SERVICE CHANGE

- Item No. 10 and 12 have been changed.
Changes begin with serial No. 6810E.

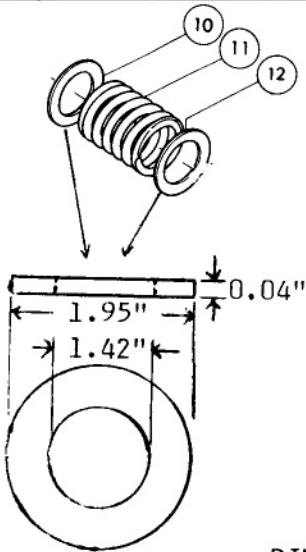
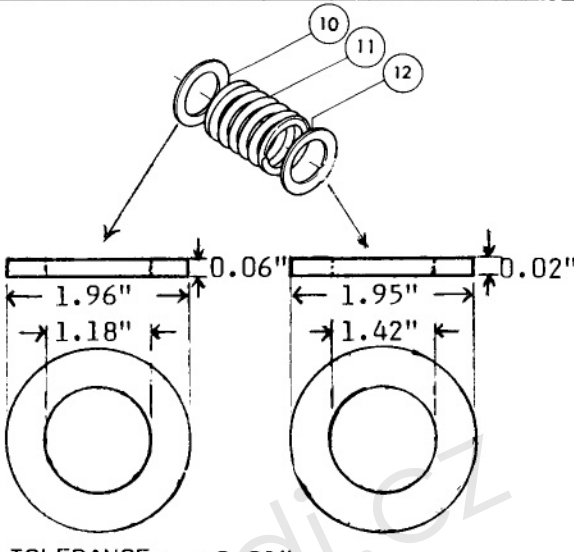
<u>DIMENSION TOLERANCE: ± 0.01"</u>				
	Part Number	Description	Part Number	Description
10	Part #253182-9	Flat Washer 36	Part #253764-7	Flat Washer 30
12	Part #253182-9	Flat Washer 36	Part #253765-5	Flat Washer 36

- Change on Internal Gear.

Item No.	Description	Type 1	Type 2
		Internal Gear	Internal Gear
20	Internal Gear	Part #221242-5	Part #221242-5A (Has a groove for flat washer)
36	Washer 65		Part #253774-4 (Added)

The above parts are completely interchangeable as a set.

The above parts are completely interchangeable as a set.

3) Change on Housing, from S/N 61,131E

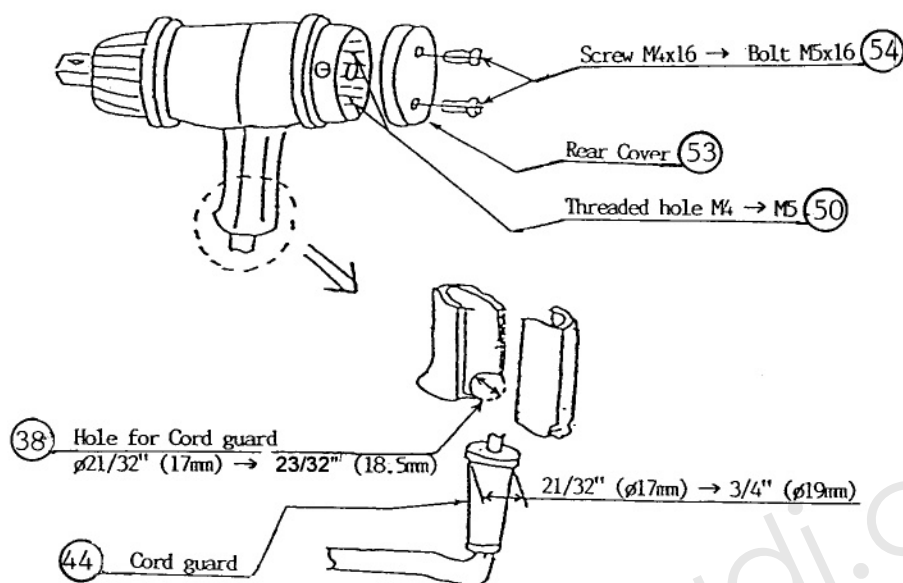
Fig.	Description	Type 1	Type 2
38	Handle Cover	Part #411213-2 (Discontinued)	Part #414959-9
44	Cord Guard	Part #682504-0	Part #682503-2
50	Motor Housing	Part #156086-3 (Discontinued)	Part #159414-1
53	Rear Cover	Part #284018-1 (Discontinued)	Part #284065-2
54	Screw	Part #911126-2	Part #922221-3

The above parts are interchangeable as a set except on items listed below.

1. Type 2 Rear Cover (Fig.54) fits Type 1 Rear Cover individually.
2. Type 2 Handle Cover (Fig.39) fits Type 1 Motor Housing if Type 2 Cord Guard is used.
